SDG&E 9/14/11 Response
A. 10-06-007 South Bay Substation Relocation Project PTC
Energy Division Data Request 08 Dated September 7, 2011
SDGE-ED-008: Questions 2-9

SDG&E October 3, 2011 Response
A. 10-06-007 South Bay Substation Relocation Project PTC
Energy Division Data Request 08 Dated September 7, 2011
SDGE-ED-008: Q 1

Figure 1: Detailed GIS Substation Project Components Map 1 of 3

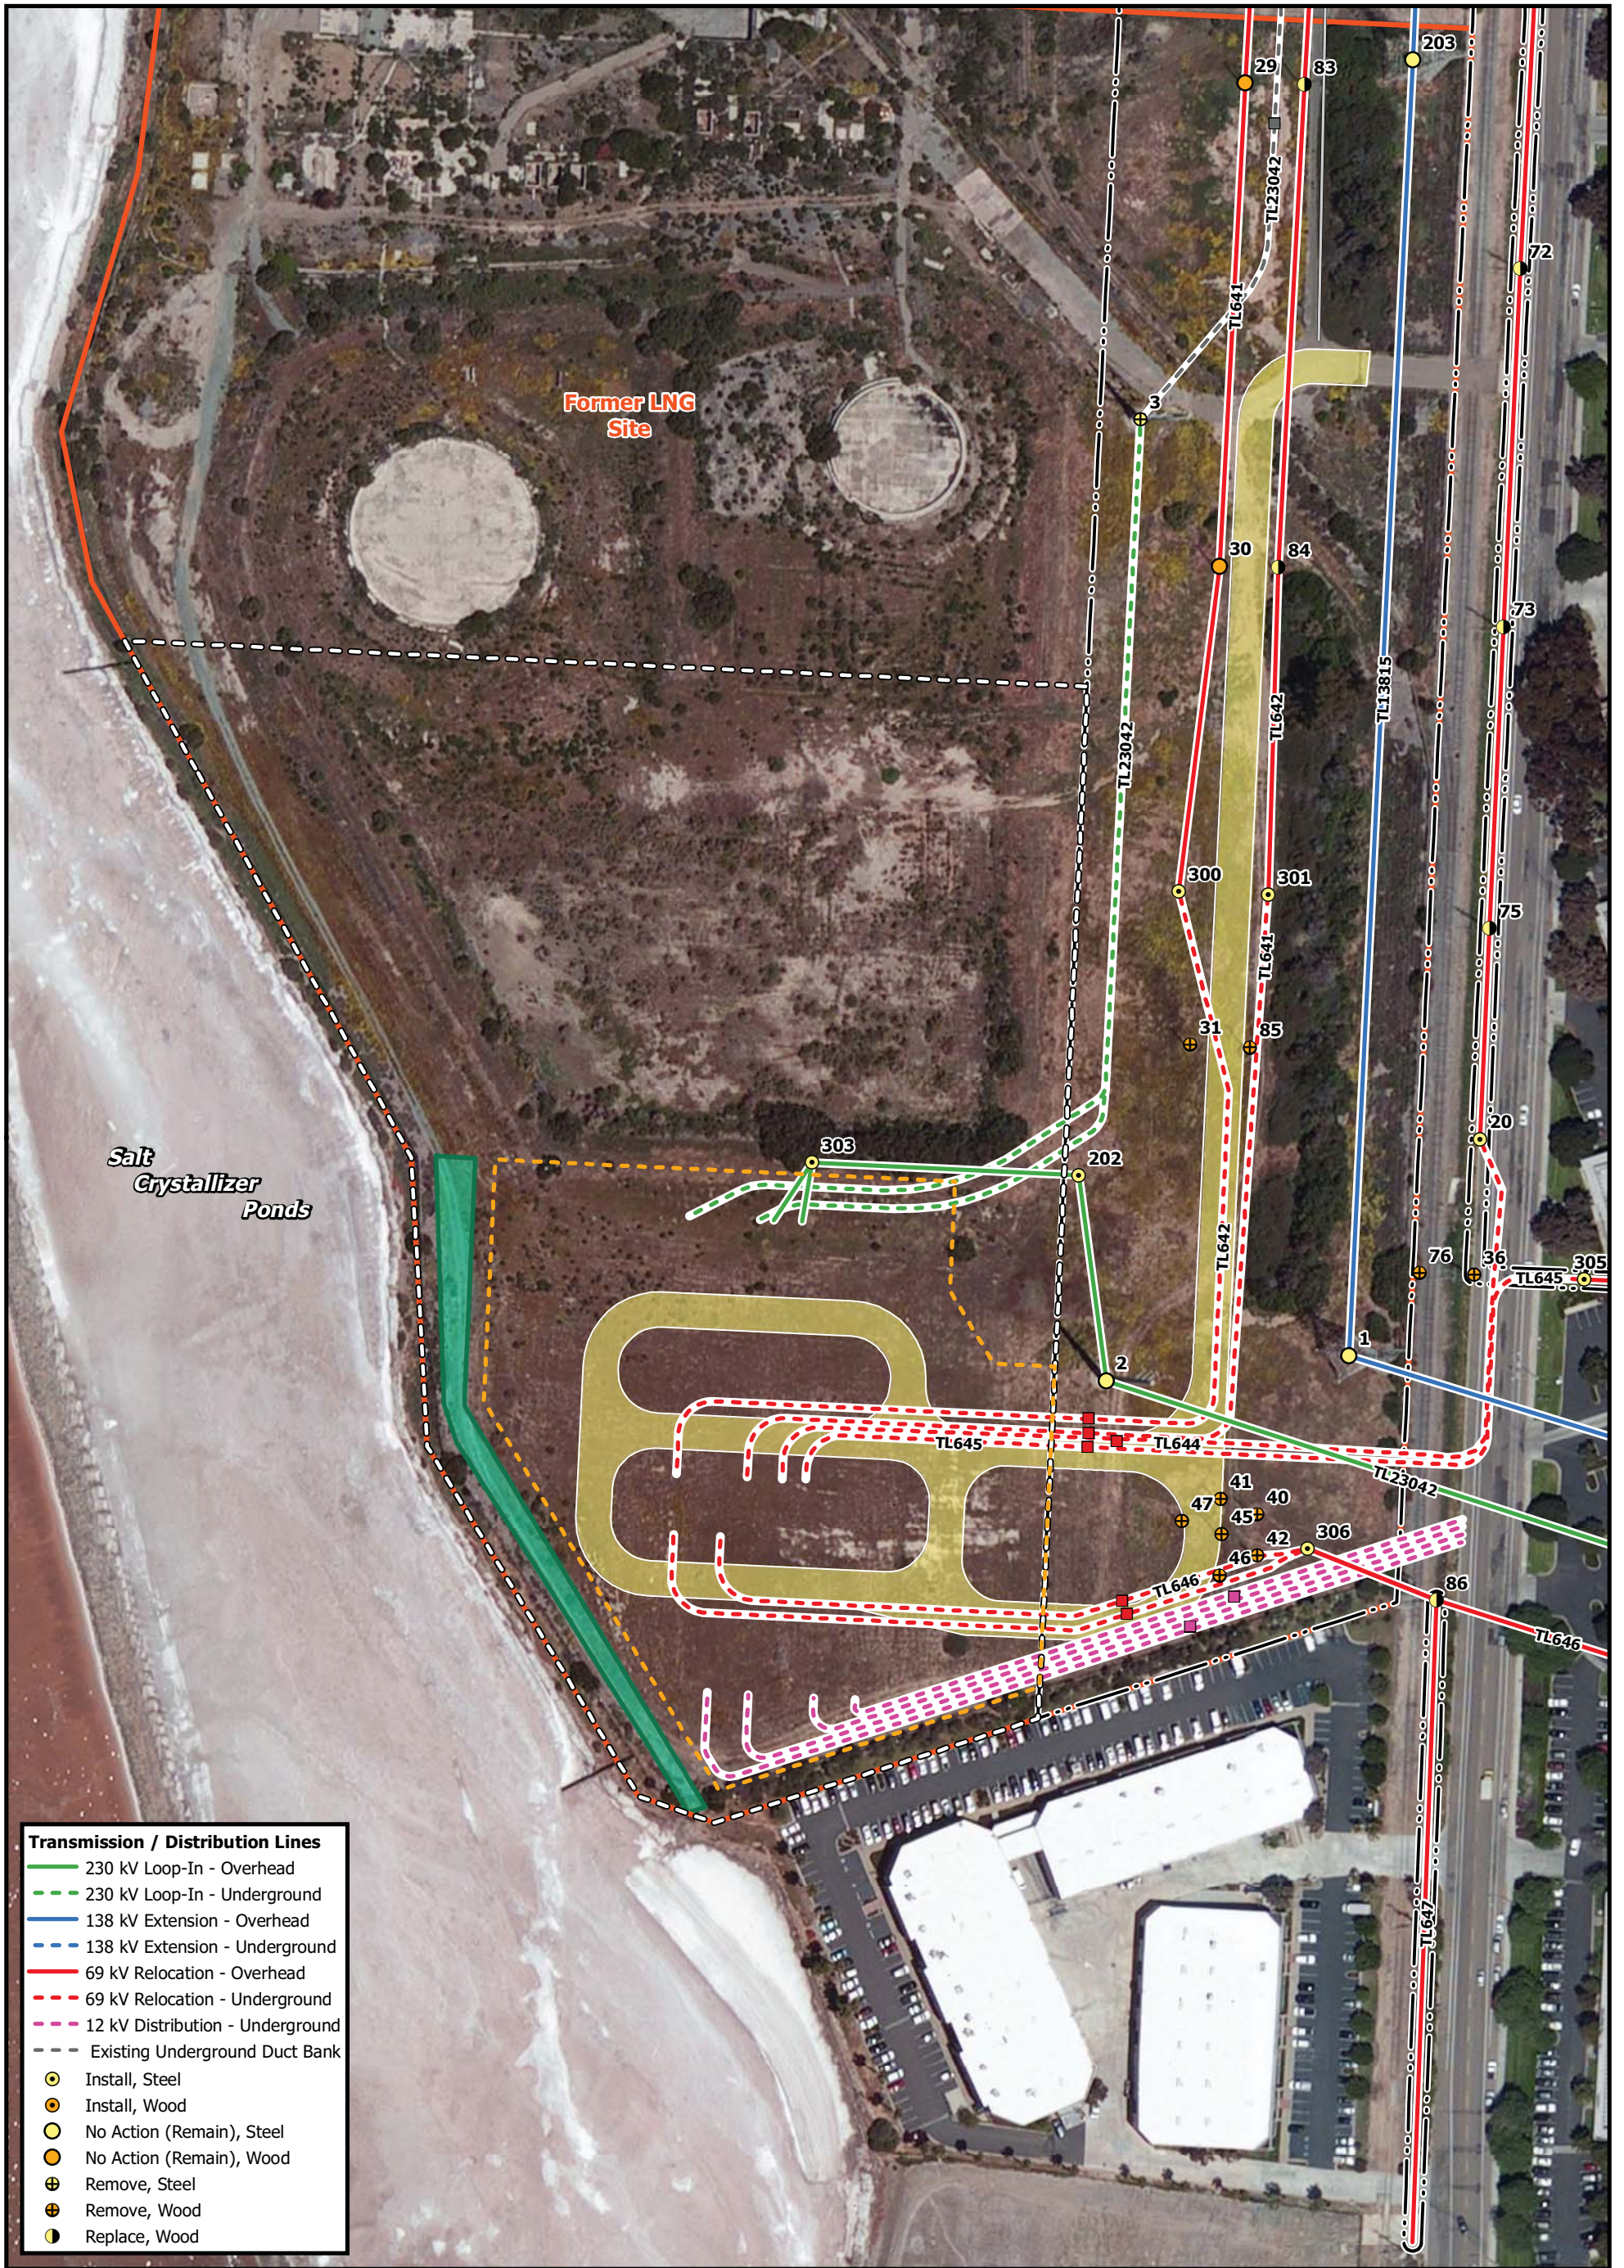
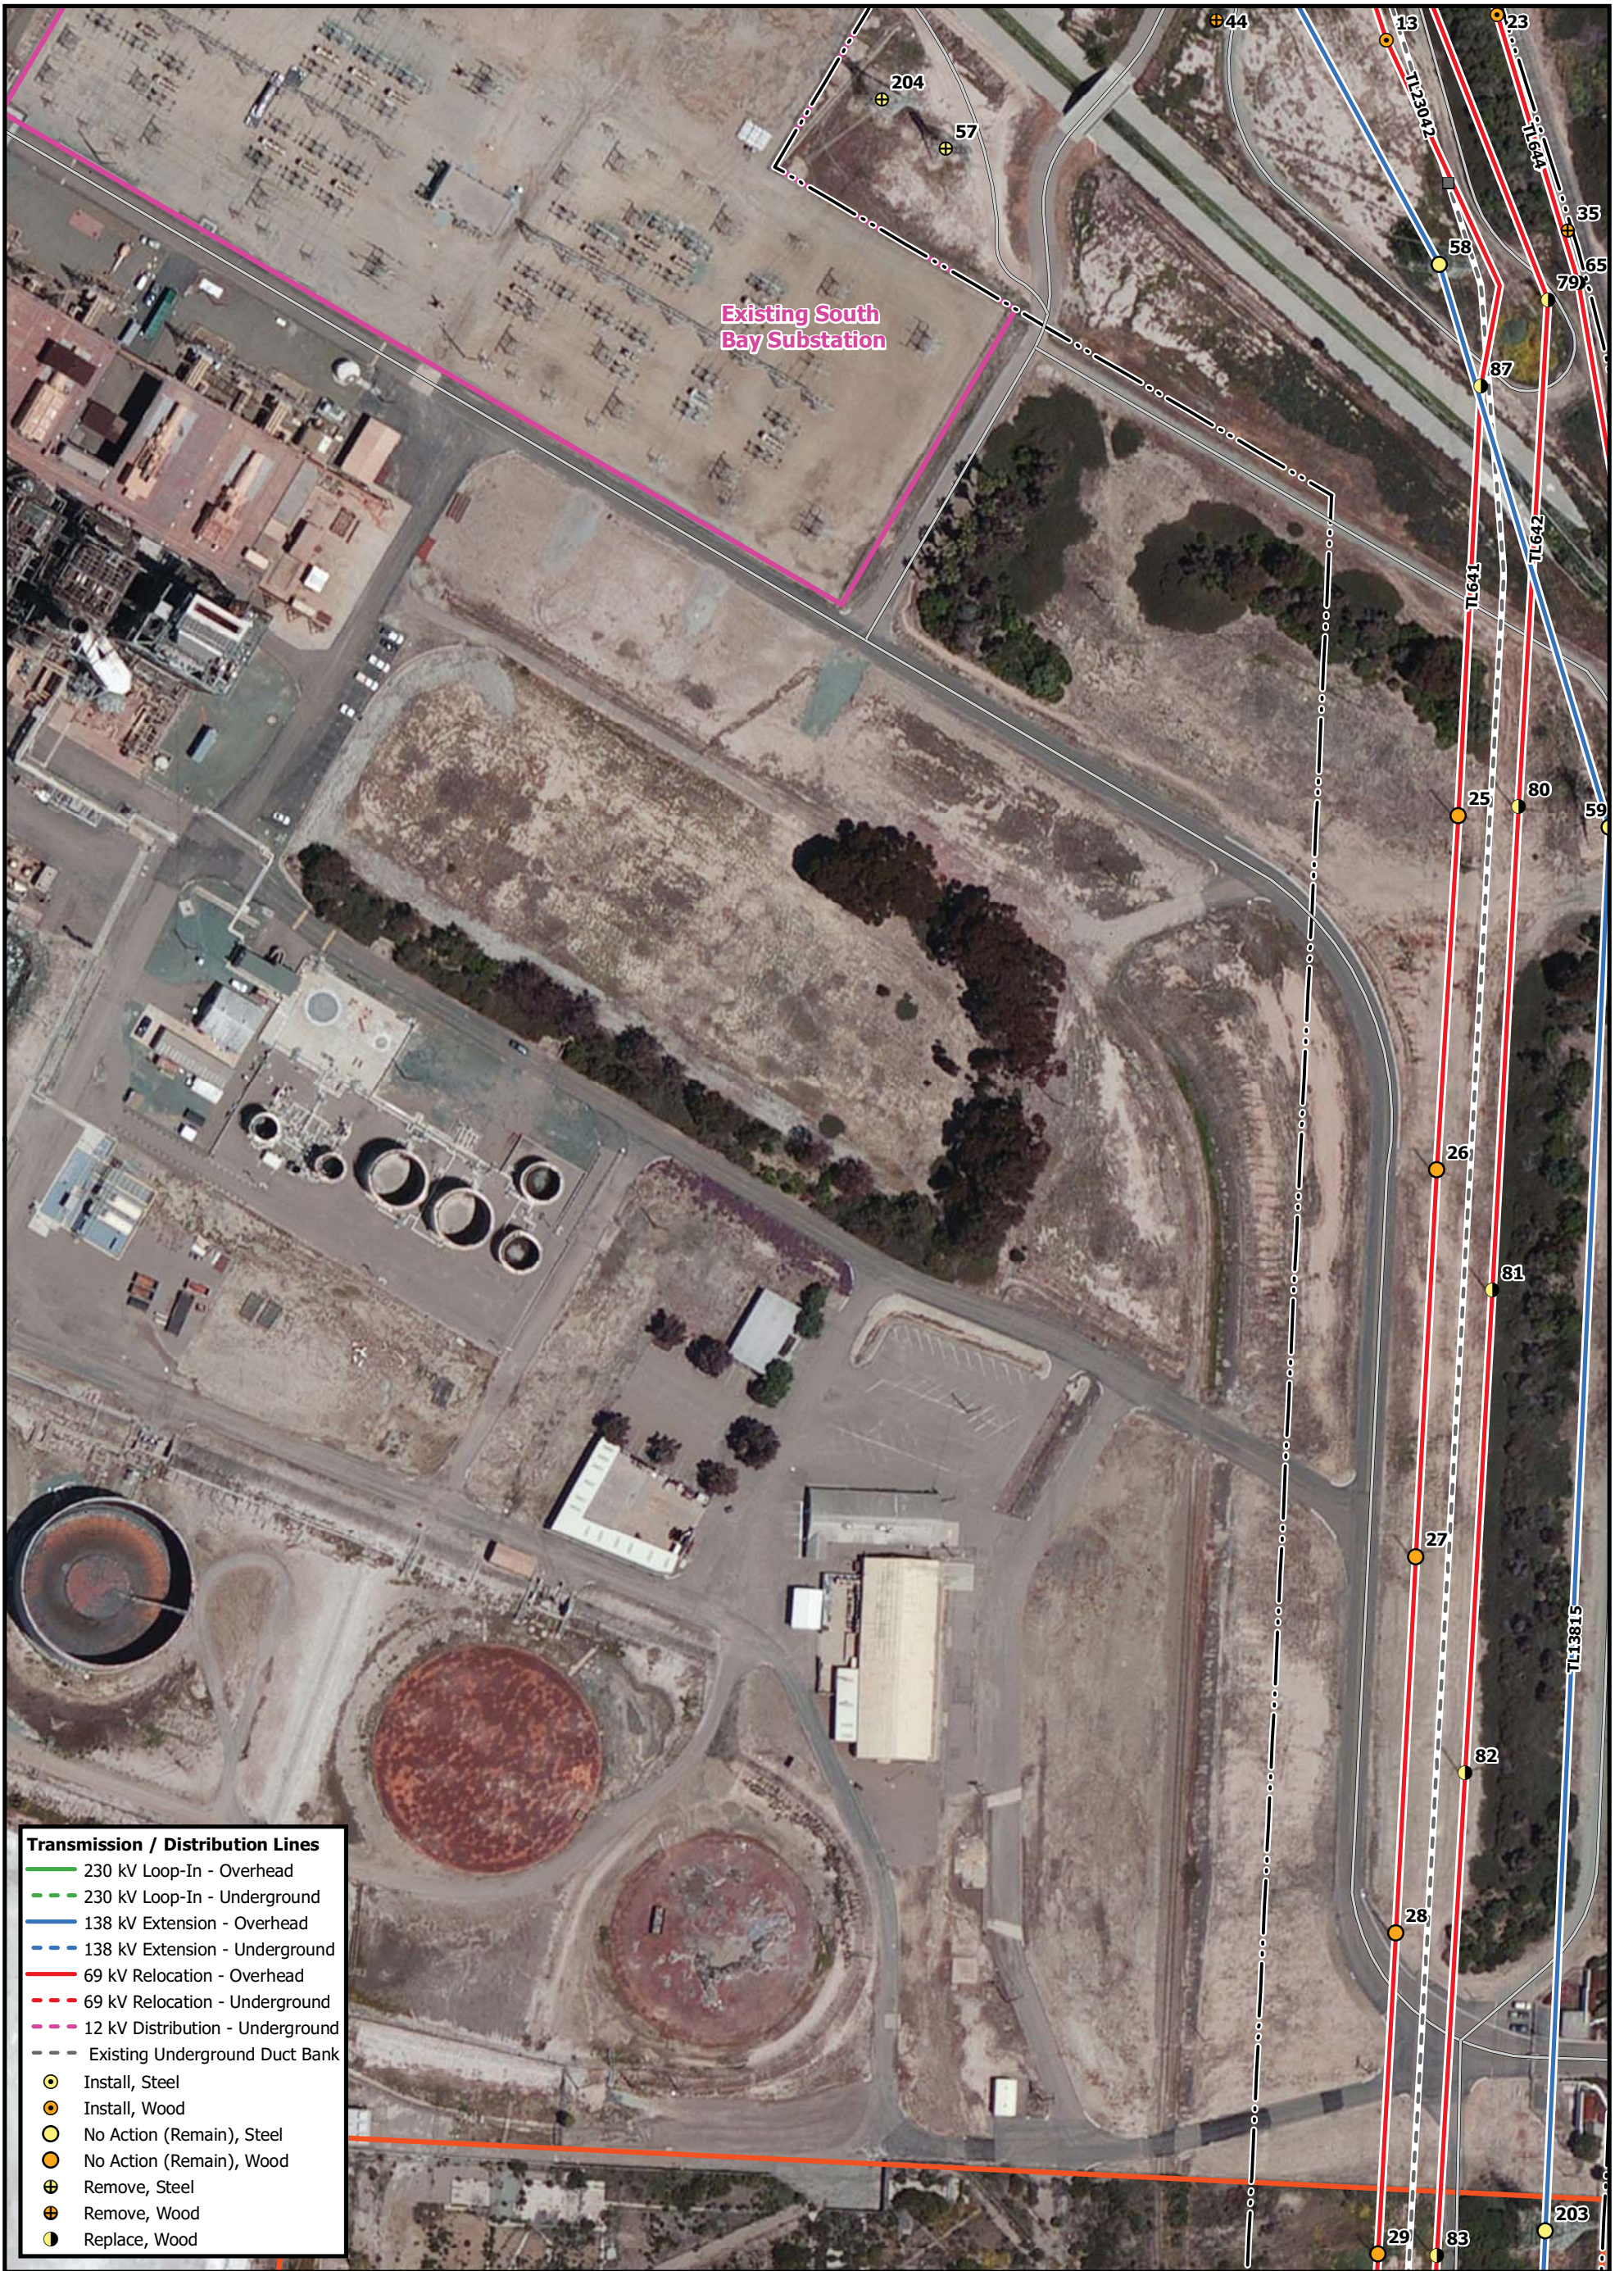
GIS Alternative: Section 2.1 of the GIS Substation Alternative Description and Preliminary Impact Analysis (May 2011) includes a description of the proposed transmission line interconnections that would be required with implementation of the GIS Substation Alternative. Please provide a map of the location of all transmission line interconnections that would be required with implementation of the GIS Substation Alternative. Please be sure to identify transmission infrastructure that would differ from the improvements identified under the Proposed Project (Air Insulated Substation).

SDG&E has not yet conducted a detailed analysis of the transmission infrastructure for the Gas-Insulated Switchgear (GIS) Substation Alternative. In order to reduce the overall costs associated with the GIS Substation Alternative, SDG&E would propose not to underground the 138 kV transmission line (as is proposed with the Air-Insulated Switchgear [AIS] Substation proposed project), so long as not undergrounding the 138 kV transmission line is technologically feasible. Since detailed engineering for the GIS Substation Alternative is not yet available, it is uncertain whether it would be technologically feasible for the 138 kV transmission line to remain overhead based on the relocation of the 69 kV transmission line (TL644) outside of the wetland area.

- Two steel structures would still be removed from the existing South Bay Substation
- No new steel structures would be installed for the 138 kV transmission line
- One new 138 kV three-wood cable pole structure would be relocated from its current position near the existing South Bay Substation getaway area onto an existing SDG&E right of way.

Figure 1: Detailed GIS Substation Project Components Map provides the GIS substation footprint and the proposed 69 kV, 138 kV, and 230 kV transmission line configurations, including existing transmission pole locations, as well as those which would be removed, replaced, or installed. Figure 2: GIS Versus AIS Interconnection Comparison Map provides a side-by-side comparison of the proposed GIS and AIS substation footprints and their associated transmission line interconnections.
